## Staff Data Requests

### C. Central Ohio BioEnergy, LLC, Case No. 14-2245-EL-REN

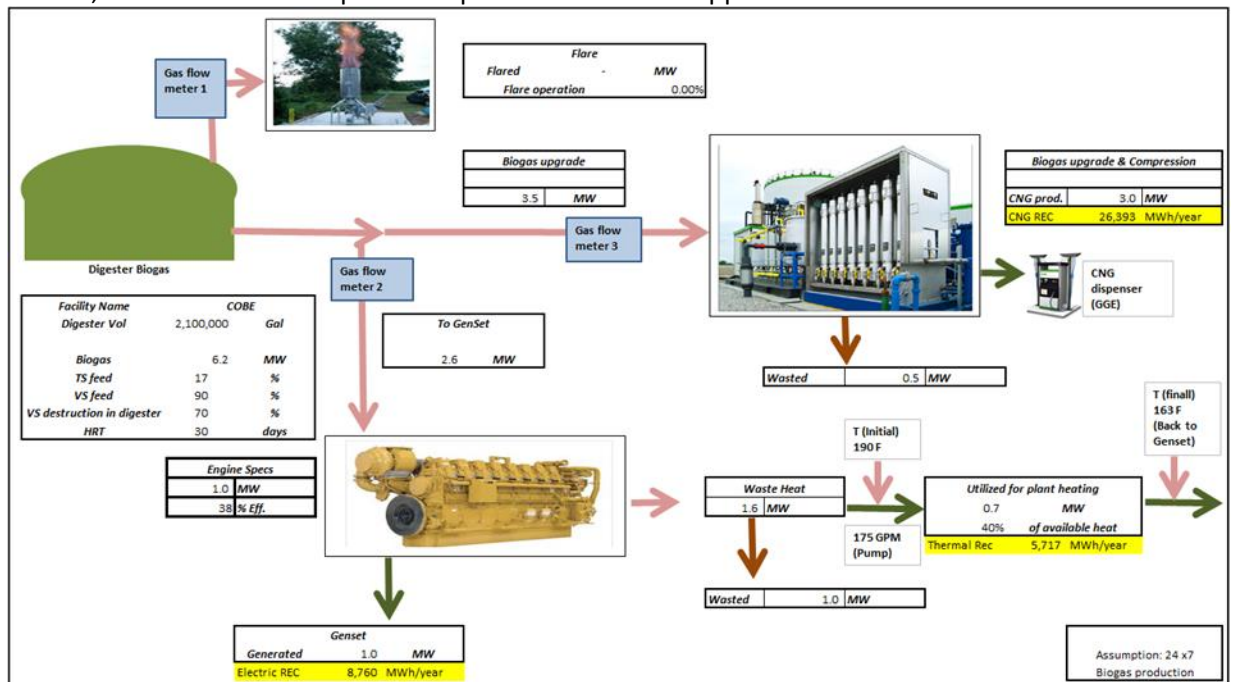
12. Regarding Section G.3 of the application, please provide a detailed description of how heat captured by each source is going to be measured and verified, including the configuration of the meter(s), the meter types(s), and meter accuracy. What is the projected in-service date of the thermal meters? Please provide documentation.

**Thermal REC:** Engine is cooled using a heat loop which circulates Glycol-Water mixture (50%) across the plant. The flow of the glycol is **175 GPM** (Pump rating, see fig.).

We have temperature sensor located in the engine which show the temperature of glycol taking waste heat from the engine. **The temperature is typically around 190° F (See fig. 1)** This glycol flows in the plant supplying heat for plant purpose (Digester heating, Floor heating, Pasteurization). **The return temperature of glycol is around 163° F (See fig. 1)**
